# SERVICE PROCEDURE

22524 / 22535  
JANUARY, 2023

**SUBJECT:** SAFETY RECALL 22524 Variation 22535  
Hex Flange Lock Nut on certain International® HV™  
Series trucks built 01/21/2022 thru 08/16/2022.

**Figure 1. Sheppard Main Steering Gear Mounting Nuts (Driver-Side)**

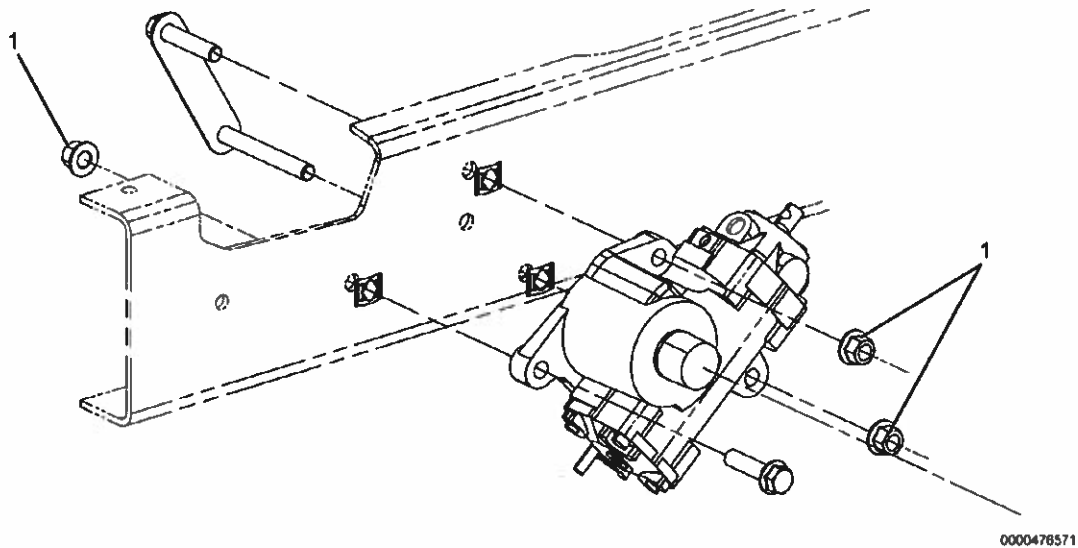
A specific hex flange lock nut used in several, but not all, steering and / or suspension locations may have not been properly formed and heat treated to Navistar's specifications and can result in a loss of joint tension as the vehicle ages. A loss of joint tension in these joints may affect vehicle handling and could contribute to a vehicle crash.

1. Main steering gear mounting nut (3)
6. Access main steering gear mounting nuts (Figure 1, Item 1).
7. Remove only one mounting nut at a time. Discard nut.

**NOTE: After installation of each nut, ensure at least one thread is protruding past the top edge of the nut.**

8. Install new mounting nut.
9. Using a torque wrench and backup wrench positioned on bolt, tighten mounting nut to 330 - 370 lb-ft (450 - 500 N·m).
10. Repeat Steps 7-9 for additional mounting nuts.

**Figure 2. Sheppard Slave Steering Gear Mounting Nuts (Passenger-Side)**

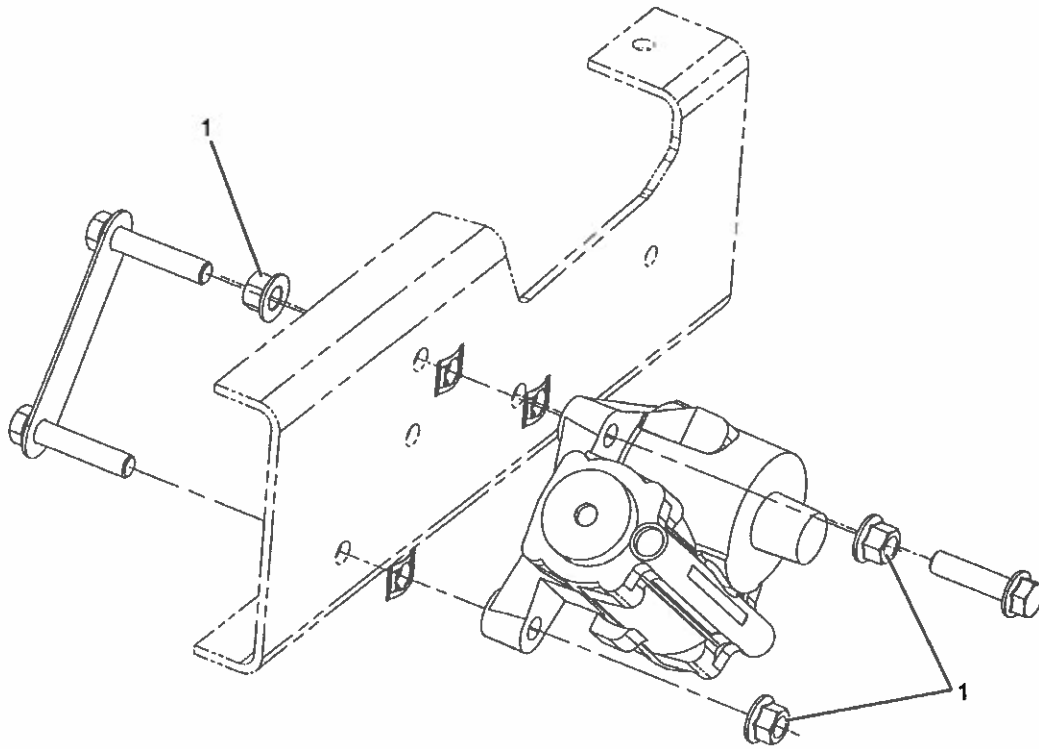
1. Slave steering gear mounting nut (3)
11. Access slave steering gear mounting nuts (Figure 2, Item 1).
12. Remove only one mounting nut at a time. Discard nut.
13. Install new mounting nut.

**NOTE: After installation of each nut, ensure at least one thread is protruding past the top edge of the nut.**

14. Using a torque wrench and backup wrench positioned on bolt, tighten mounting nut to 330 - 370 lb-ft (450 - 500 N·m).
15. Repeat Steps 12 -15 for additional mounting nuts.
16. Close and latch hood.
17. Remove wheel chocks.
